CITY PLANNING COMMISSION
202 Coleman A. Young Municipal Center
Detroit, Michigan 48226
Phone: (313) 224-6225 Fax: (313) 224-4336
e-mail: cc-cpc@detroitmi.gov

TO: City Planning Commission
M.F. for C.A.
FROM: Christopher Gulock, CPC Staff
RE: **Proposal of the Midtown Project, LLC to modify the plans for the existing PD (Planned Development District) zoning classification on District Map No. 4, Article XVII of the 1984 Detroit City Code, for properties at 3750, 3780 and 3800 Woodward Avenue generally located on the east side of Woodward Avenue between East Alexandrine Avenue and Mack Avenue for the construction of a four-story medical office building and a 3 ½ level parking structure (RECOMMENDING APPROVAL)**
DATE: July 30, 2013

TO: City Planning Commission
FROM: Gregory F. Moots, CPC staff *GM*
DATE: July 29, 2013
RE: **Site Plan review of proposed perimeter fence for Stonecrest Medical Center, 15000 Gratiot Avenue.**

2012056
 Floor Plan Level 1

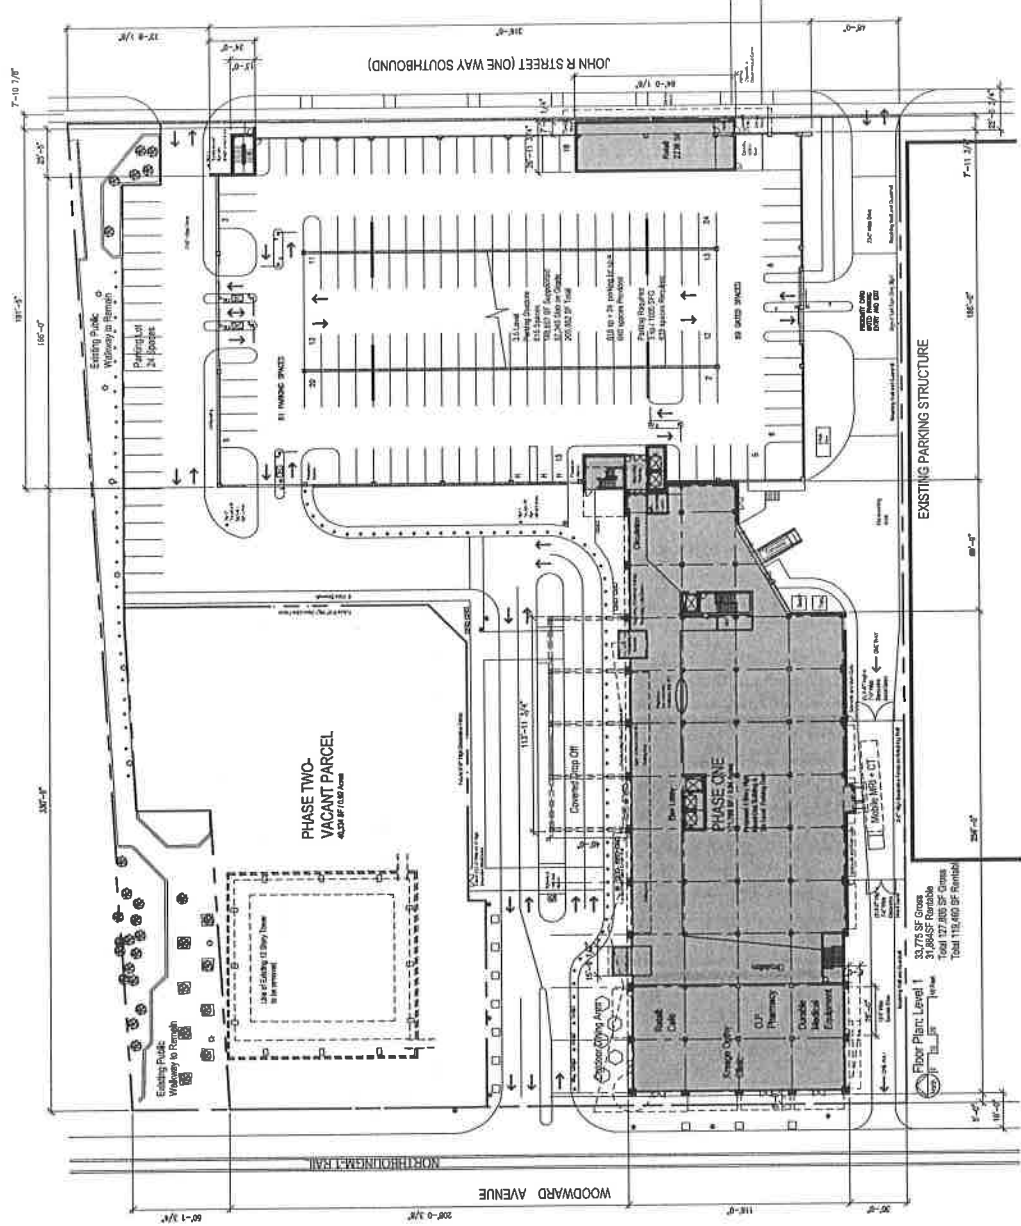
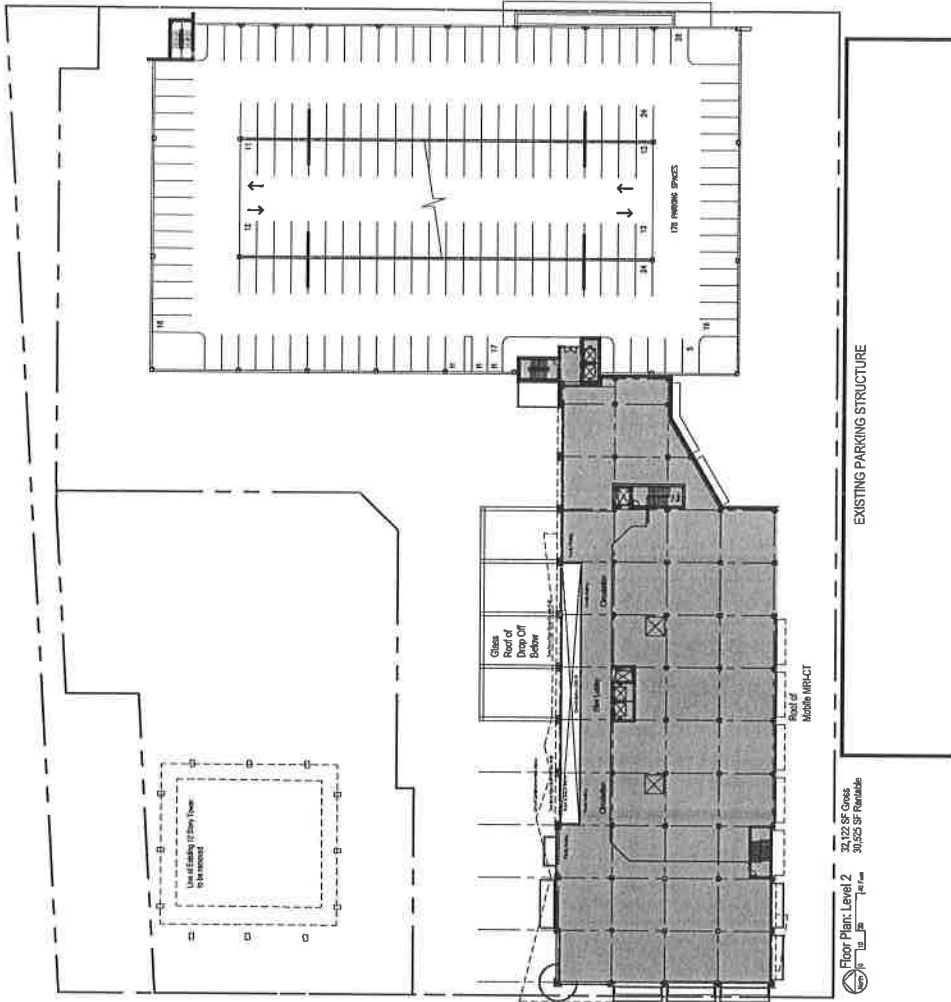
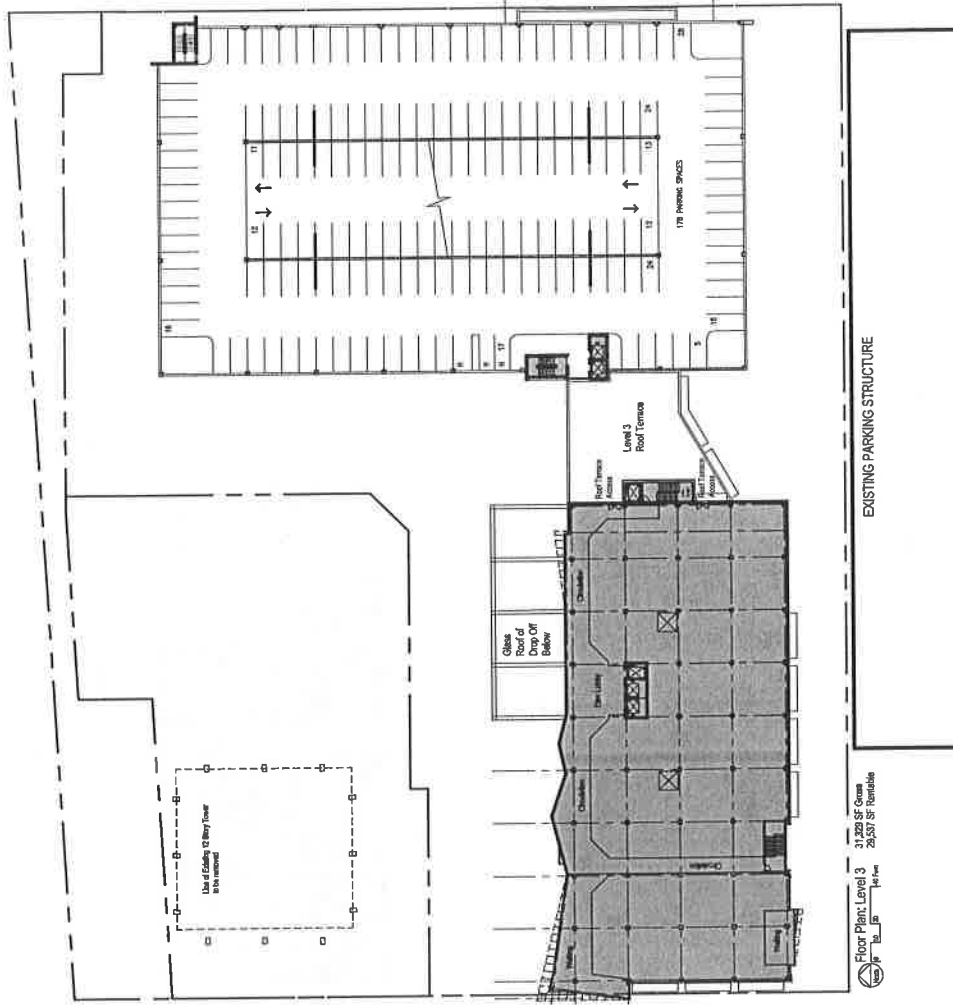
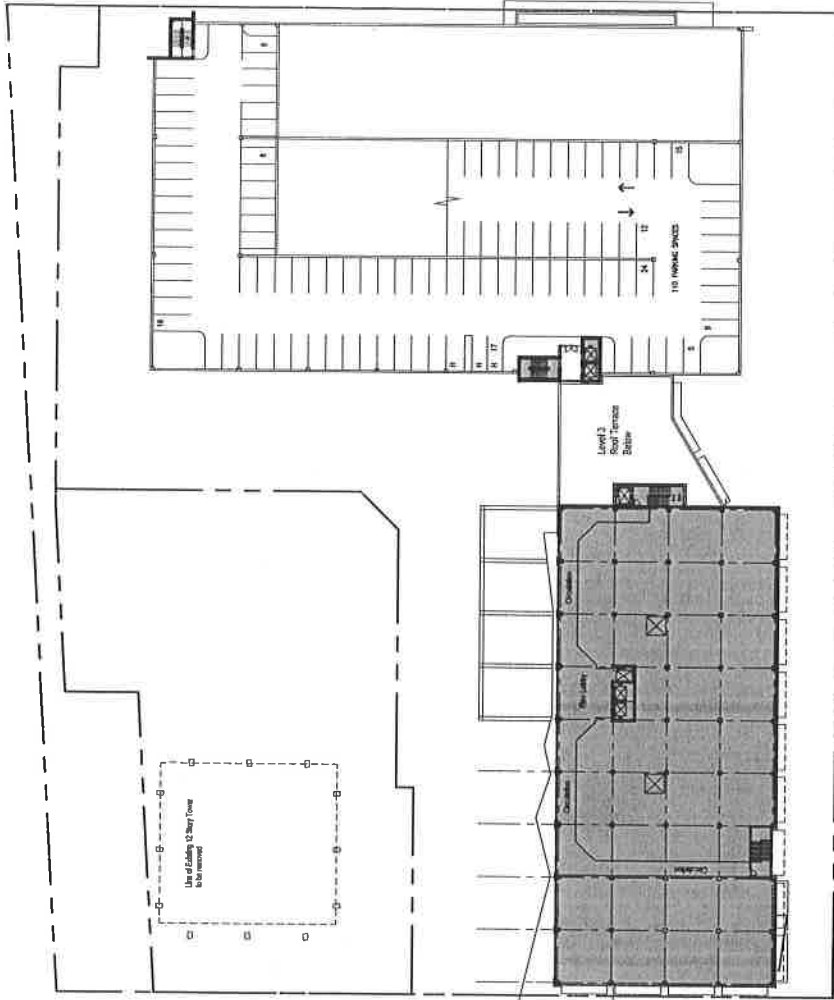
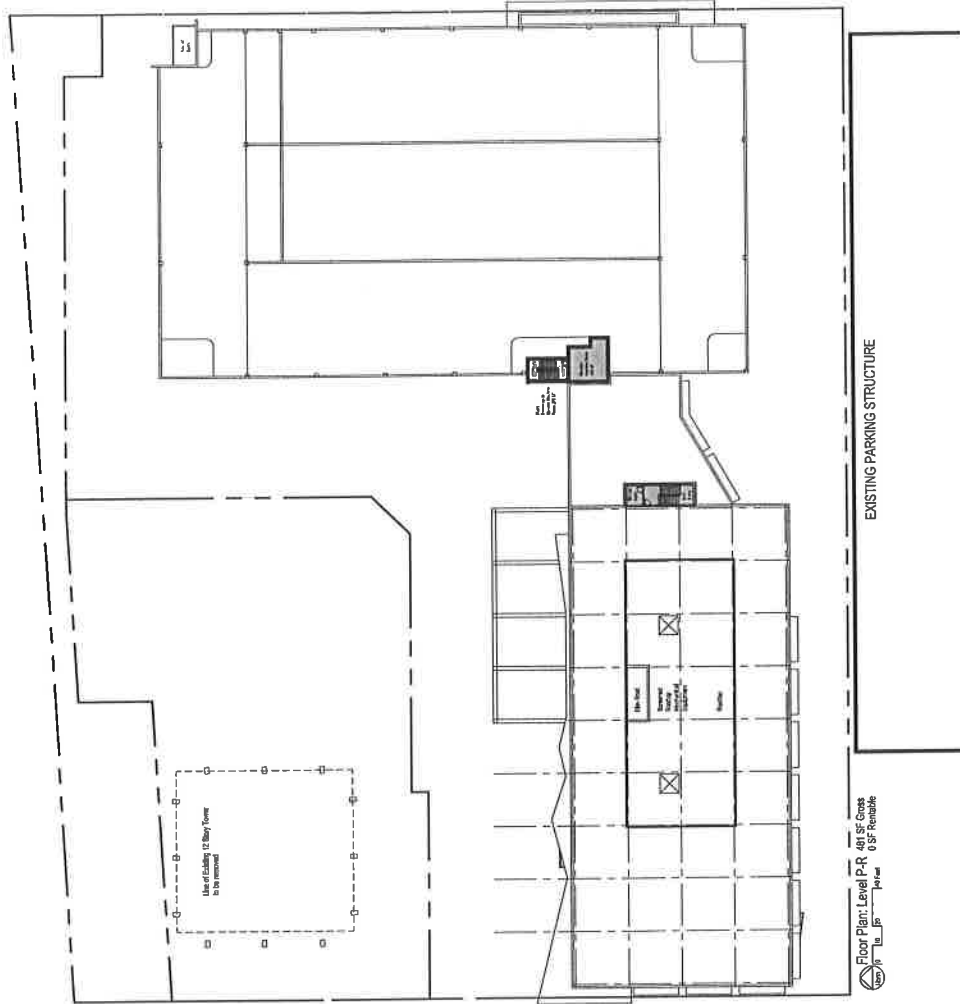
Since the May 16th public hearing, staff has conducted numerous discussions in cooperation with other City departments including P&DD regarding the proposed project. Since that time, the developer has agreed to make the following changes (these changes have been reflected in revised site plans):

- 1) Move the building along Woodward Avenue 5 feet eastward in order to provide a larger pedestrian zone along Woodward Avenue;

- 2) Remove any conceptual plans for the phase two portion of the project; this would result in a separate application being submitted at a later date; the developer agreed to install a decorative 6 foot high fence separating phase one and phase two;
- 3) Eliminate from the plans any encroachment onto the existing public walkway at the north end of the site;
- 4) Redesign of the Woodward Avenue driveway which would be used for deliveries based on feedback from the State of Michigan; and
- 5) Add four wayfinding signs to help with circulation within the site.

The petitioner has included a landscaping plan with the submittal. Staff is generally supportive of the proposed landscaping plan. Shifting the entire building 5 feet eastward has resulted in the loss of a portion of the landscaped setback along John R. Furthermore, removing the development from the walkway to the north has resulted in the loss of some landscaping on the north end of the parking structure. Staff is supportive of these changes in light of the resultant benefits.

Originally, the plans for the project included 615 spaces in the 3 ½ story parking deck and 115 parking spaces in the surface area north of the structure for a total of 730 parking spaces. The revised plans include 616 spaces in the parking deck and 24 parking spaces in the surface area north of the structure (not on phase two) for a total of 640 spaces.

The Legislative Policy Division (LPD) - City Planning Commission (CPC) staff recommends approval of Midtown Project, LLC's request to modify the approved plans for the existing PD zoning classification on District Map No. 4 of the Detroit Zoning Ordinance at 3750, 3780, and 3800 Woodward Avenue subject to the following condition:

That final site plans, elevations, landscaping, lighting and signage plans be submitted to the Legislative Policy Division, CPC staff for review and consistency with approved plans prior to making application for applicable permits.

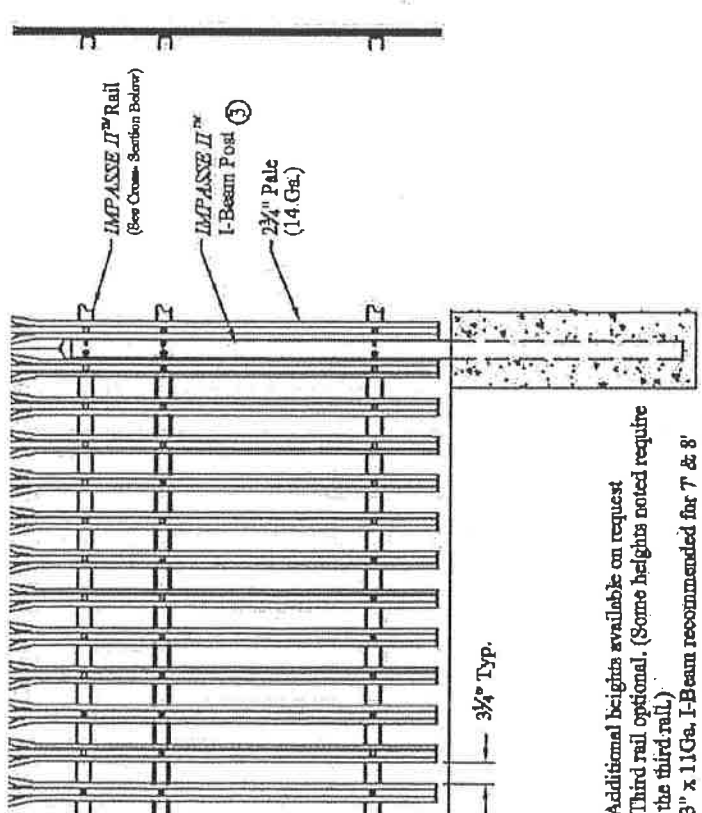
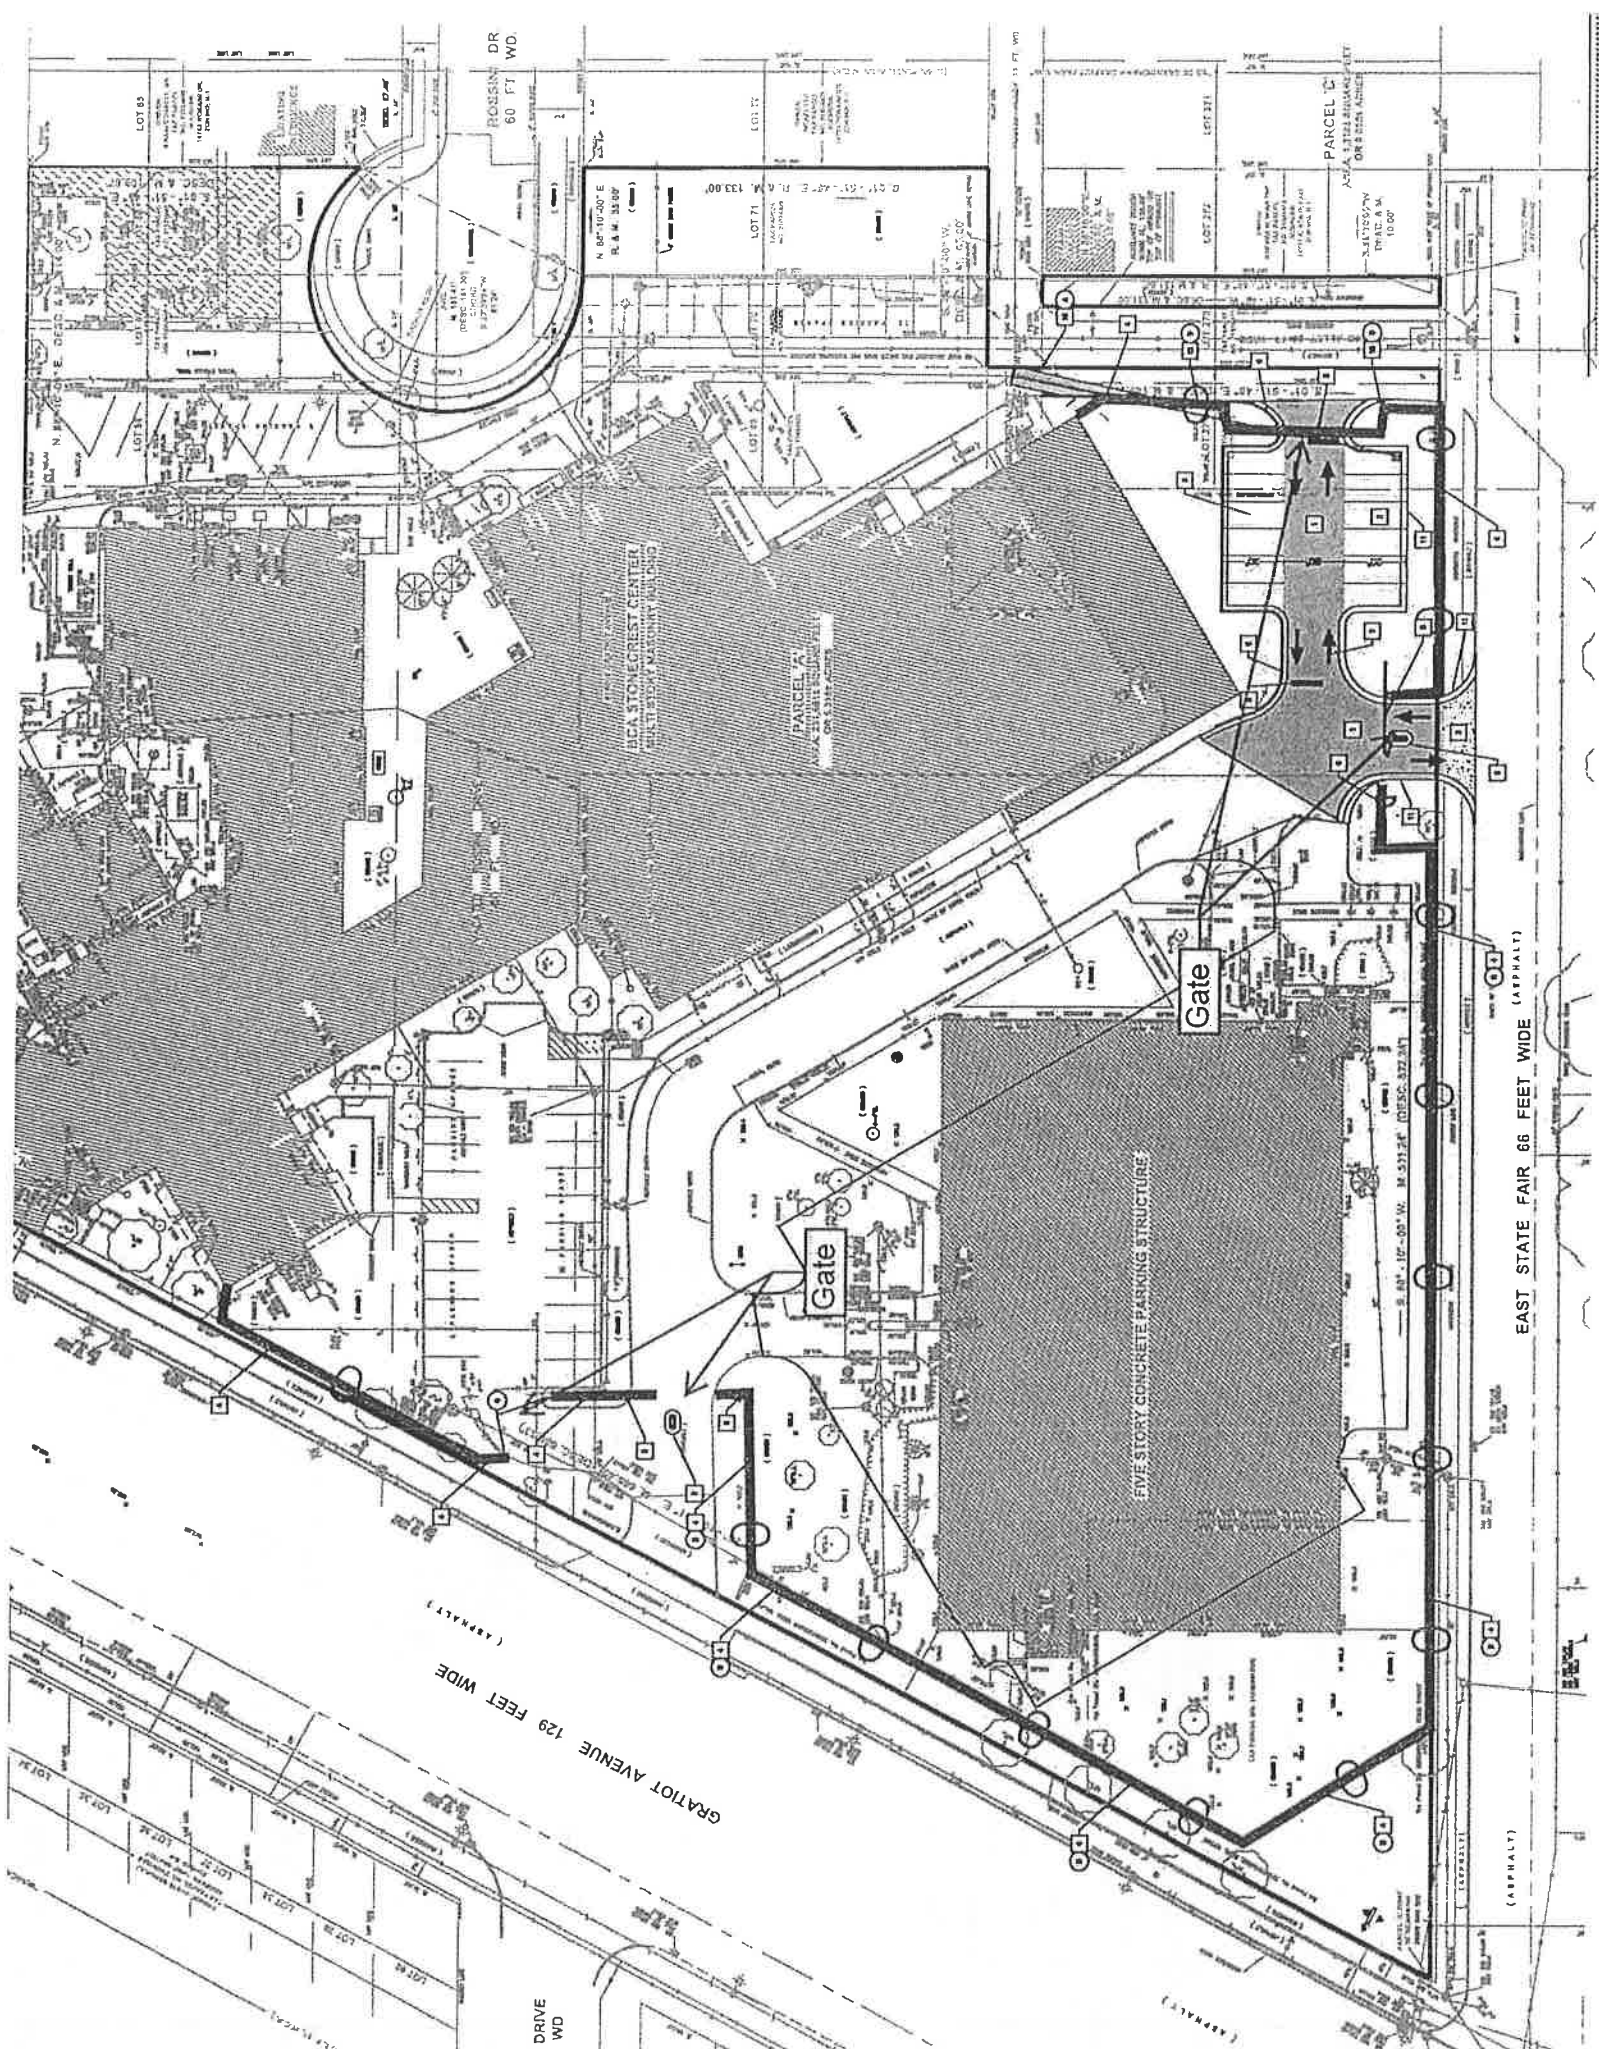
City Planning Commission (CPC) staff has been requested to review a building permit for the property located at 15000 Gratiot, the Stonecrest Medical Center (the former Saratoga General Hospital), on property zoned PD (Planned Development). The requested modification is for a ten feet tall perimeter fence around the Western and southern portions of the site to protect the temporary and forthcoming permanent new parking lot. Recently cars have been broken into creating problems for staff and patrons. According to the applicant, "This fence height is being requested in order to ensure security for both the medical center staff and well as the visitors of the facility. The facility staff feels that a fence of this height is warranted based on their history with the facility."

Generally, the installation of a fence would be considered a "minor Modification" per the criteria set forward in Sec. 61-3-97 of the zoning ordinance. Customarily, the review for a permit, such as this would be conducted by staff as the Commission has delegated that authority. The matter is being brought before the CPC on this occasion because the applicant wishes to install a ten (10) feet tall fence, and staff is of the opinion that this is an excessive height. Details of the proposed type of fence and pictures of it installed elsewhere (though the height of the fence at these other locations is unclear) are attached. A single-family residence is adjacent immediately to the east of the site across the alley from the proposed fence along E. State Fair, which at that location has been pulled slightly west to the edge of the parking lot. Currently the site is bounded on the east by a low brick wall.

Previously, staff approved the installation of a temporary parking lot on the location of the to-be-demolished parking deck shown on the site plan. The permanent surface parking lot and its required major PD modification is anticipated to come before the CPC at a September meeting.
